Geological And Hydrogeological Issues

Hilltop Action Group

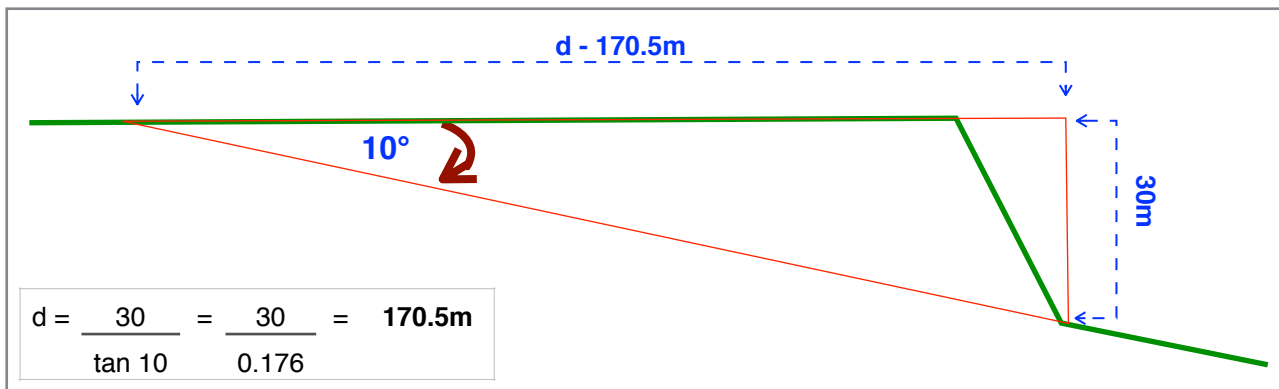
*Given the geological dip of the natural strata recorded at approximately **10- 12degrees** to the east, and the surface water flow from west to east, it is anticipated that the groundwater flow will follow the geological structure of the site and also flow in a west to east direction through the site.*

If the nearest cut is 30m deep then any property within approximately 170m will be lying on or above strata at the base of the excavations. (See diagram below.) Groundwater will be drawn away from the land beneath these properties into the excavations lowering the water table.
